Application No.: 10/783,292

Docket No.: SPINE 3.0-448 CONT

REMARKS

The present Amendment is in response to the Office Action mailed December 15, 2004 in the above-identified application. Enclosed herewith is a Petition requesting a one month extension of time for resetting the deadline for responding to the Office Action from March 15, 2005, to and including April 15, 2005.

FIG. 5A 8A

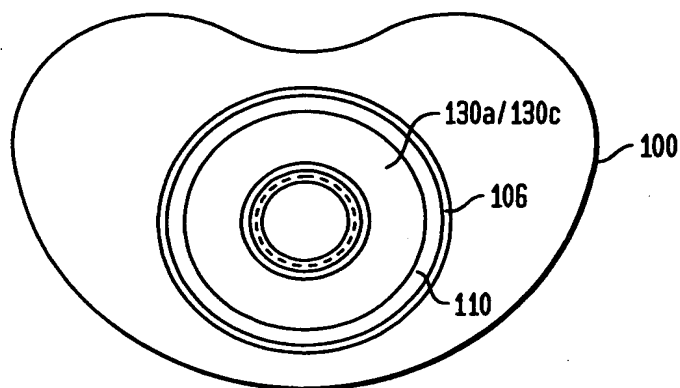
In the Office Action, the Examiner objected to the use of reference characters "138b" and "138d" to designate both radial slots and spiral slots. In response, Applicants have amended FIGS. 5 and 7 as indicated in the attach Letter to the Official Draftsmen.

FIG. 6A 9

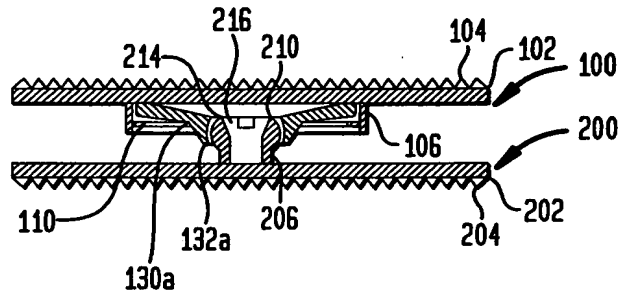
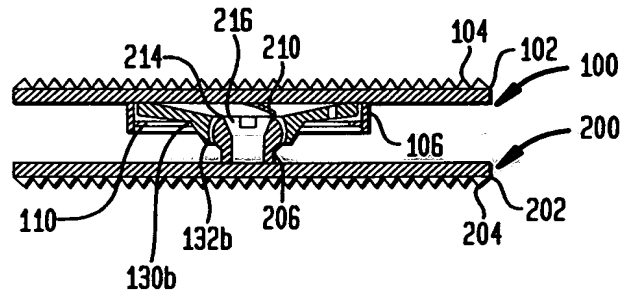
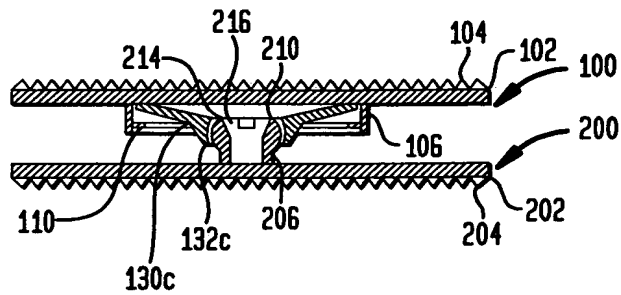
In the present amendment, Applicants have added new claims 6-10, which are fully supported by the originally filed specification and add no new matter. Support for the limitations found in new claims 6-10 are found in drawing FIGS. 9-12 and the specification at paragraphs 30-38.
